Product Change Notice (PCN)

PCN Number: PCN-0456768R-01

Product(s) Affected: *UJ2-B-HR-G-TH*

PREVIOUS SAME SKY DETAIL / IMAGE	NEW SAME SKY DETAIL / IMAGE

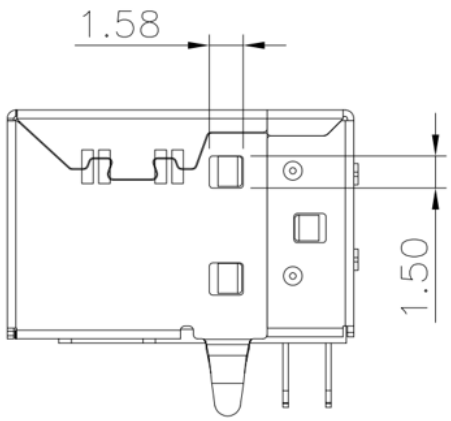
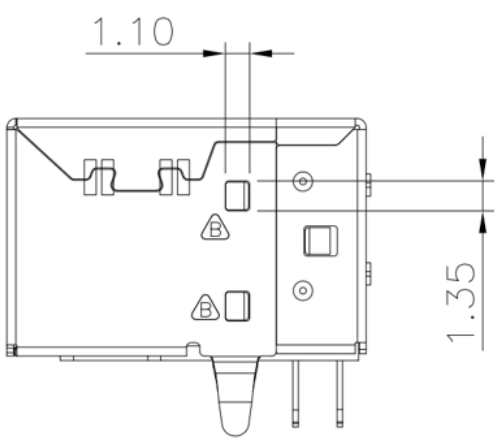
Description of Change: Reduced the snap lock hole size from 1.5mm x 1.58mm to 1.35mm x 1.10mm.
